To: Planning Commission
From: Christina Robertson-Gardiner, Senior Planner
RE: LEG 19-0003-Beavercreek Road Concept Plan Zoning and Code Amendments
Date: September 16, 2019

Figure 1 - Goal 5 Site Inventory- Beaver Creek Road Concept Plan Design Process

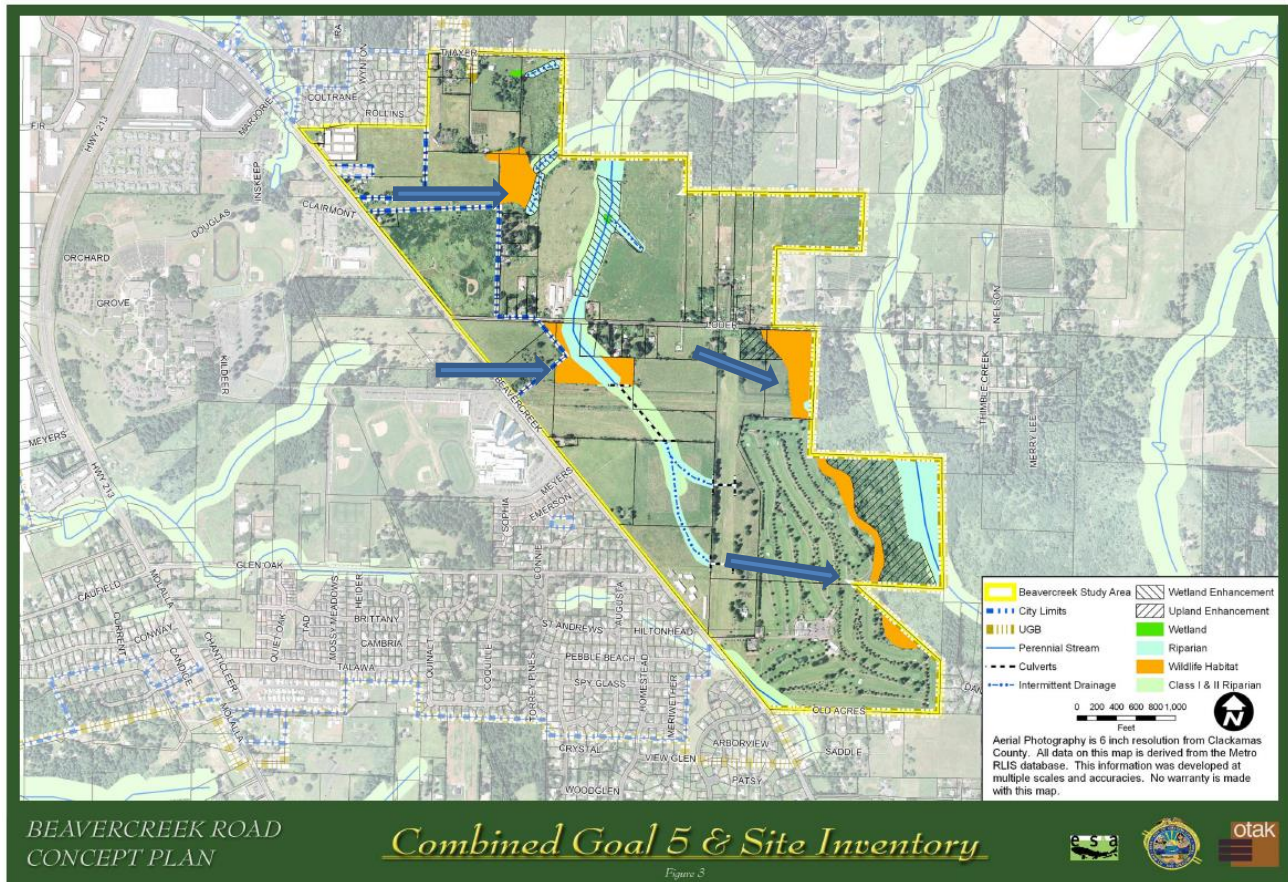
Below are three maps that further described this issue. The 1st map- Figure 1, looked at streams, wetlands and habitat areas during the Concept Plan design process prior to the adoption of the revised Title 13 code amendments. The areas identified in orange are labeled as habitat area.

Figure 2 Natural Resource Overlay District (NROD)

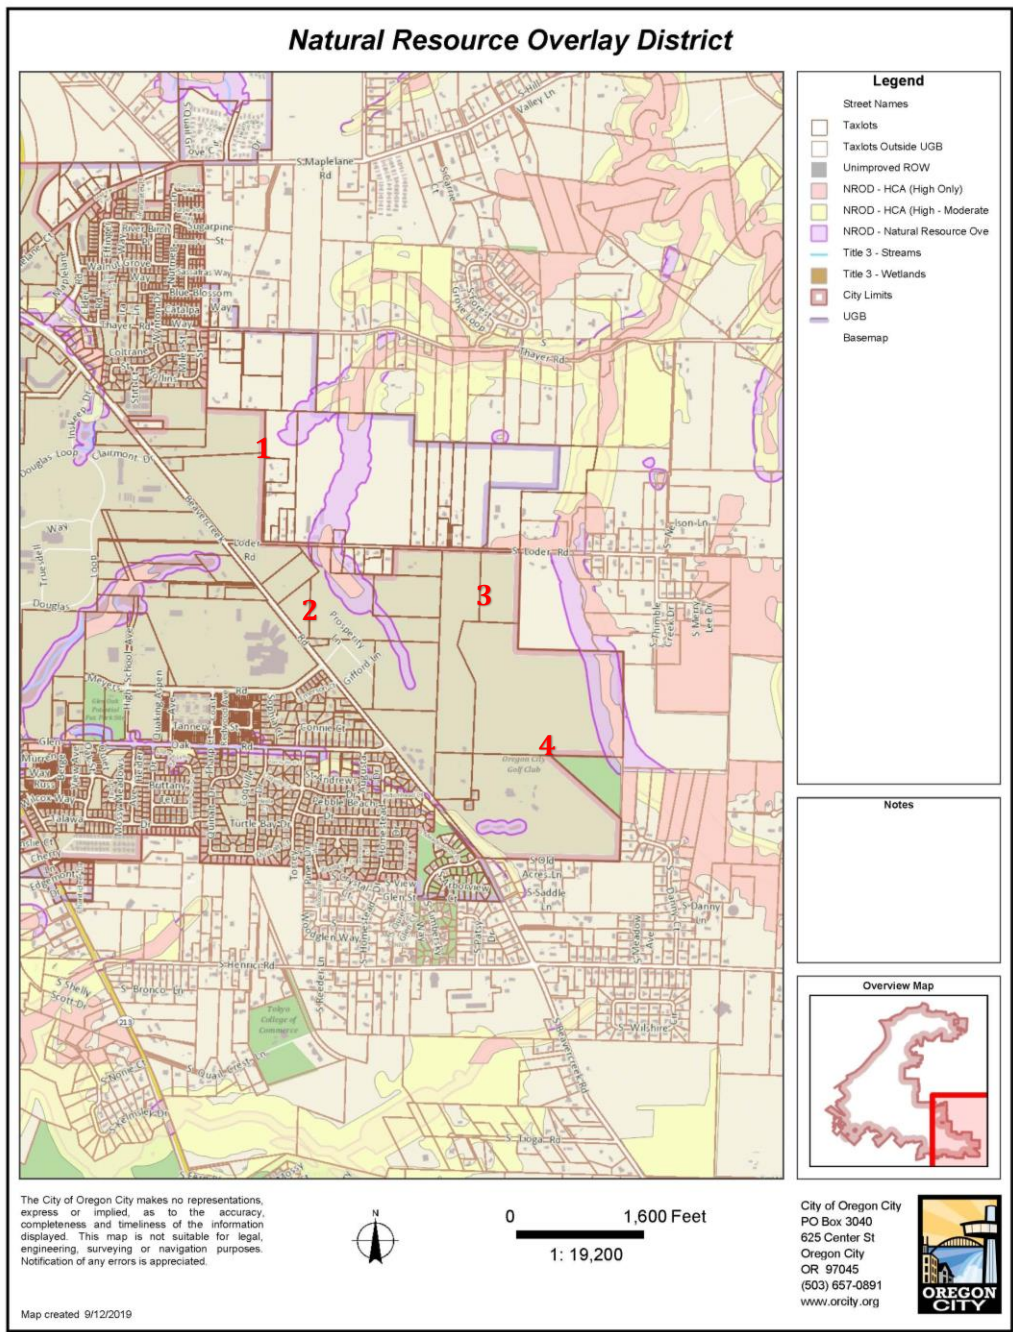
The 2nd Map- Figure 2 consists of the adopted Metro Title 13 compliant Natural Resource Overlay District. The habitat areas are identified as salmon pink, and the Natural Resource Overlay District is identified as bright pink. Please note that the Metro identified habitat areas regulated under OCMC 17.49 Natural Resource Overlay District are smaller than the habitat areas identified by the consultant team above in Figure 1 and have been demarcated with red numbers (1-4)

All of the currently regulated habitat areas located within the Natural Resource Overlay District in this area are protected through OCMC 17.49.

Figure 3- Geologic Hazards + Natural Resource Overlay District (NROD)

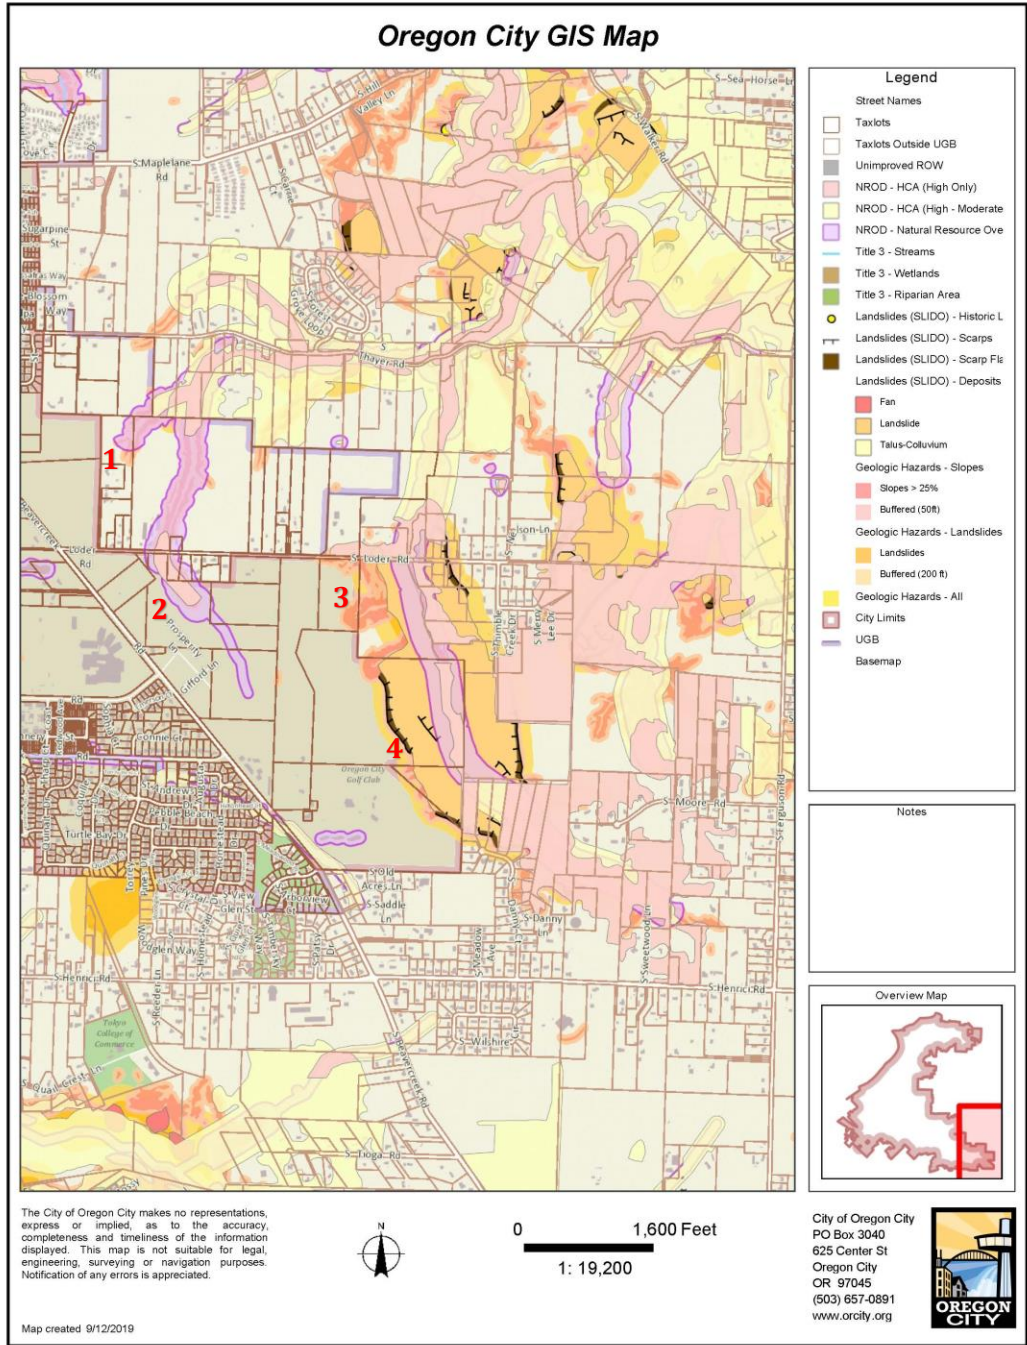
The areas located outside of the NROD District and identified as orange in Concept Plan Inventory in Figure 1 are further protected through the Geologic Hazards District. Figure 3 below identifies areas with historic landslides, sloped over 25% slope and 50 buffers around these features. Development is greatly reduced and oftentimes restricted within the Geologic Hazards Overlay District.

The Natural Resource Overlay District (OCMC 17.49) and Geologic Hazards (17.44) account for much of the concept plan identified habitat area associated with Thimble Creek Canyon (area 4) at the far SE quadrant of the plan and some of Area 3 closer to Loder Road.

The Concept Plan identified habitat area proposed to be zoned Campus Industrial (areas 1 and 2) that abuts the existing vegetative corridor which runs north along the airfield and crosses over Loder Road is not fully regulated by these two overlay districts.

Staff recommendation: Staff does not recommend any revisions to the proposed code amendments.
